SUBJECT: HUMBOLDT BAY POWER PLANT UNIT 3 - ISSUANCE OF AMENDMENT
REGARDING SPENT FUEL CASK HANDLING (TAC NO. L52634)

SAFETY EVALUATION BY OFFICE OF NUCLEAR MATERIAL SAFETY AND SAFEGUARDS
AND THE OFFICE OF NUCLEAR REACTOR REGULATION
RELATED TO AMENDMENT NO. 37 TO FACILITY OPERATING LICENSE NO. DPR-7
PACIFIC GAS AND ELECTRIC COMPANY
HUMBOLDT BAY POWER PLANT, UNIT 3
DOCKET NO. 50-133

Figure 2. Double-acting counterbalance valve system for the davit crane

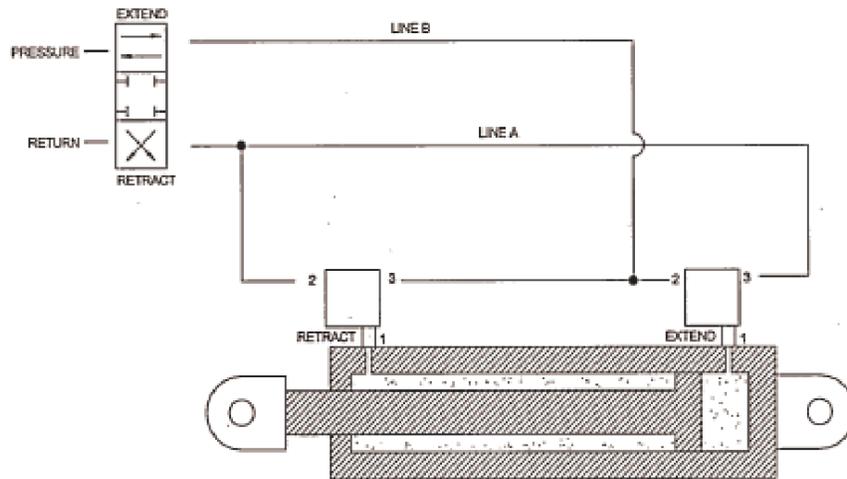
Describing the dynamic effects on the system from sudden movement, the licensee stated, in its response, dated June 3, 2005, that the counterbalance valves protect the davit crane against additional loads imparted by any hydraulic line failure or loss of hydraulic pressure. Figure 2 shows the counterbalance valves and identifies extend and retract hydraulic lines as Lines B and A. If Line B fails catastrophically during a load lift, the check valve in the extend-side counterbalance valve prevents the reverse flow from the extend side of the cylinder, thus locking the cylinder in place. If Line A fails during load lowering, the loss of pressure at Port 3 causes the extend-side counterbalance valve to close preventing the venting of hydraulic fluid from extend side of the cylinder, thus locking the cylinder in position. A lock-up of the cylinders causes the crane to make a normal stop and remain in safe condition without requiring any manual actions. All active lifting components are accessible and can be repaired or replaced with a load on the crane without risk of a load drop.

The failure of the return line, as shown in Figure 2, in any of the four cases does not result in any loss of control of the load, as the counterbalance valves will continue to control the travel at the designated speed by the orifice size in the counterbalance valves. Directly mounting the counterbalance valves to the cylinder eliminates the potential for a line failure at the cylinder hydraulic connection.

In all cases, the cylinder is protected against a catastrophic line failure. The three-way valve shown in Figure 2 prevents pump pressure from reaching the retract side and extend side simultaneously.

The staff accepts the licensee's response which shows that although the davit crane does not employ holding brakes (1) it has passive safety features of hydraulics to stop and hold the load; and (2) it is equipped with the counterbalance valves protecting it against additional loads imparted by any hydraulic line failure or loss of hydraulic pressure. In addition, wear of strands is not an issue, because they are used below the design capacity, the crane has a limited use, and the licensee will inspect the strands before each lift and replace them, if needed.
